MIL "ON" DTC P0A0F, P3190, P3191, P0171 Due to Purge VSV Vacuum Line Separation

Service Category Engine/Hybrid System

Section Engine Control

YEAR(S)	MODEL(S)	ADDITIONAL INFORMATION
2011 – 2013	CT200H

Figure 1. Location of Authorized Modifications Label on 2011 – 2013 CT 200h

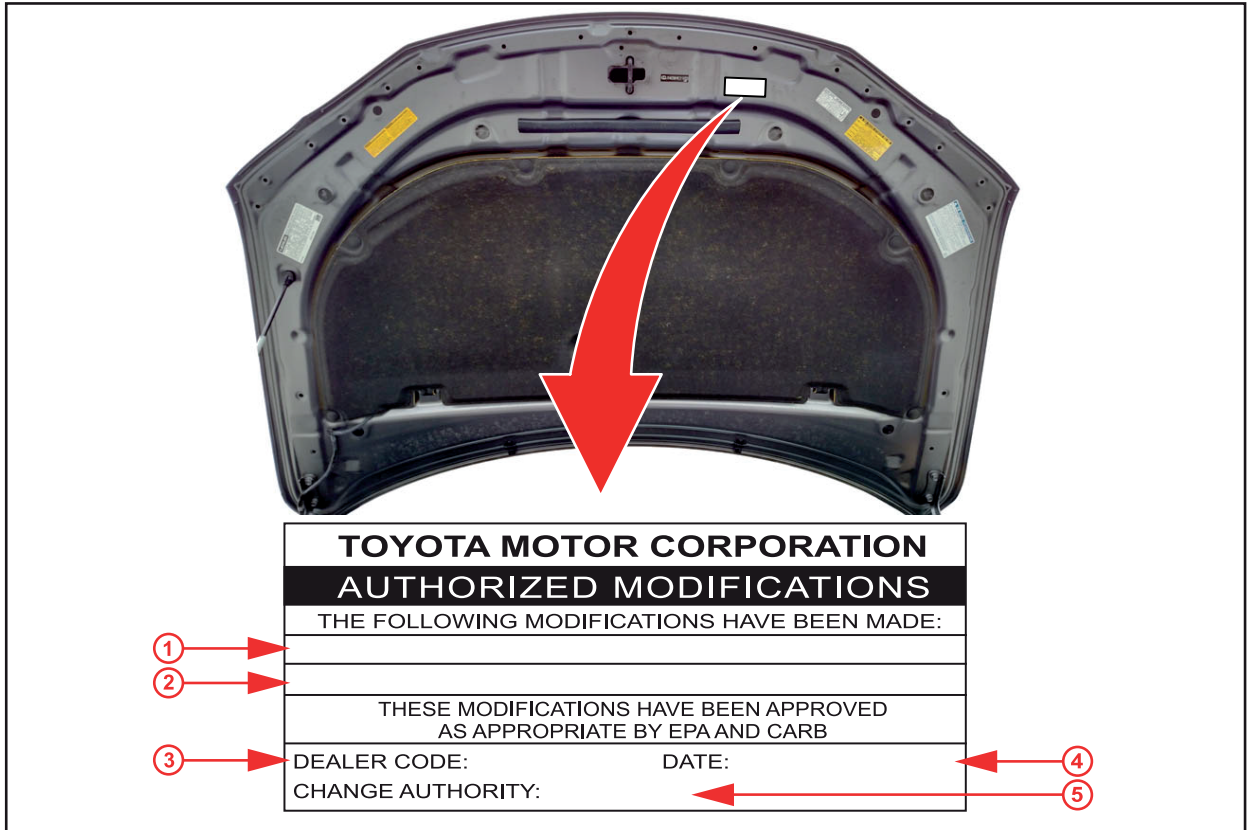
2. Check for the Authorized Modifications Label affixed to the vehicle in the location shown in Figure 1. Confirm if the ECM (PCM) calibration has been updated. If the calibration ID listed is NOT the latest ECM (PCM) calibration — go to step 3.

4. Install the Authorized Modifications Label.
 - A. Using a permanent marker, enter the following information on the label:
 - ECM part number [*Refer to the **Parts Information** section for the **NEW PART NUMBER***]
 - Calibration ID(s) [*Refer to the **Calibration Information** section for the **NEW CALIBRATION ID***]
 - Dealer Code
 - Repair Date
 - Change Authority [***This bulletin number***]
 - B. Affix the Authorized Modifications Label to the vehicle at the location shown in Figure 1. The Authorized Modifications Label is available through the MDC, P/N 00451-00001-LBL.
5. Test drive the vehicle to confirm proper vehicle operation.
